Developer Services
Southern Water
Sparrowgrove House
Sparrowgrove
Otterbourne
Hampshire
SO21 2SW

Your Ref
APP/16/00167
Our Ref
PLAN-013134
Date
09/03/2016

Proposal: Remove conservatory and bay windows. Internal and external alterations, raised terrace and erection of car port and store building.
Site: Broad Oak, Copse Lane, Hayling Island, PO11 0QB.
APP/16/00167.

Southern Water MapGuide Browser

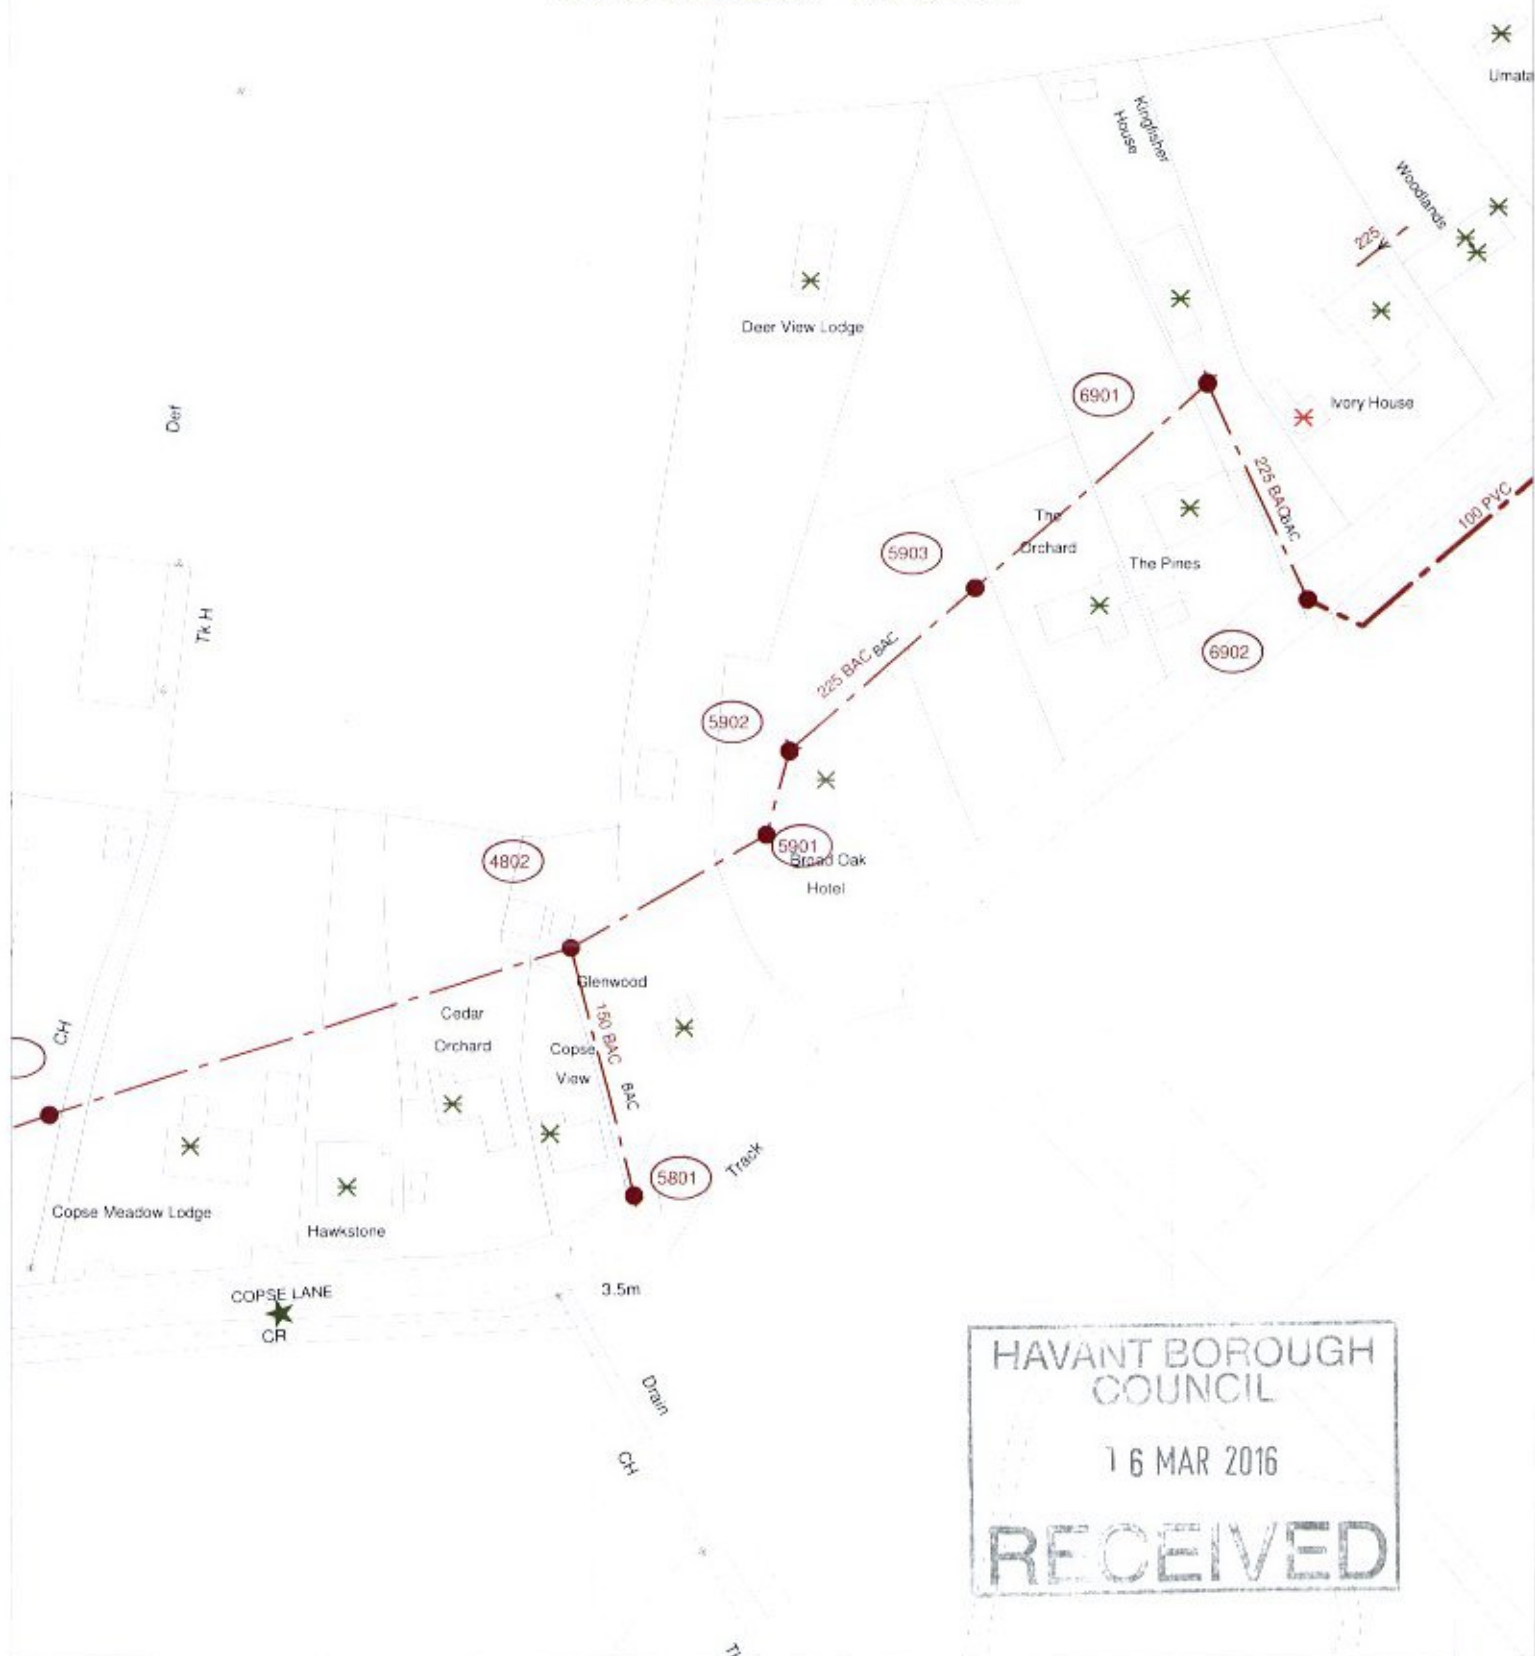
Please find attached a plan of the sewer records showing the approximate position of a public foul sewer with in the proposed development. The exact position of the public foul sewers must be determined on site by the applicant before the layout of the proposed development is finalised.

1. The 225mm diameter sewer requires a clearance of 3 metres either side of the sewer to protect it from construction works and allow for future access for maintenance.
2. No development or new tree planting should be located within 3 metres either side of the centreline of the public sewer
3. No new soakaways should be located within 5 metres of a public sewer.
4. All other existing infrastructure should be protected during the course of construction works.

In order to protect drainage apparatus, Southern Water requests that if consent is granted, a condition is attached to the planning permission. For example "The developer must advise the local authority (in consultation with Southern Water) of the measures which will be undertaken to divert the public sewers, prior to the commencement of the development."
